LIGIER JS F3

Ligier JS F3 | Tech Bulletin

#14 – 1.5.2023

STEERING ARM 08-02-033 B.1 LH & RH

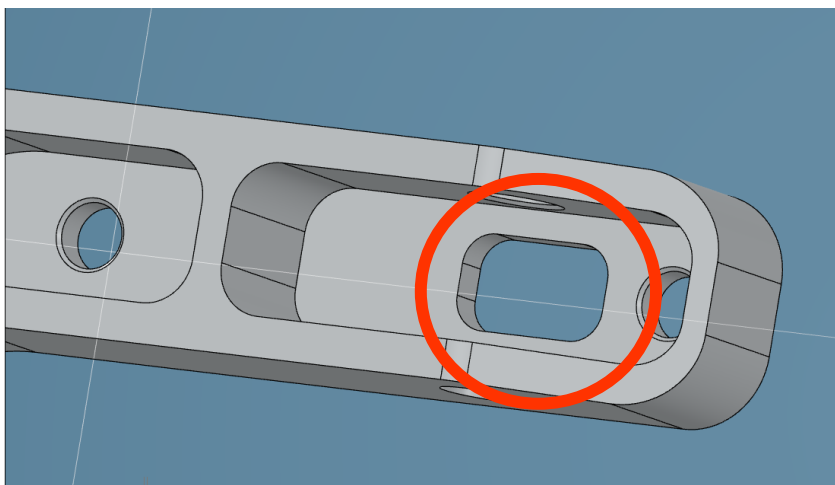
It is critical that only the current style F3 Steering Arm (green, bellow-bottom) is in use. The additional clearance combats potential interference. Please contact Ligier Automotive if you require the current version Steering Arm.
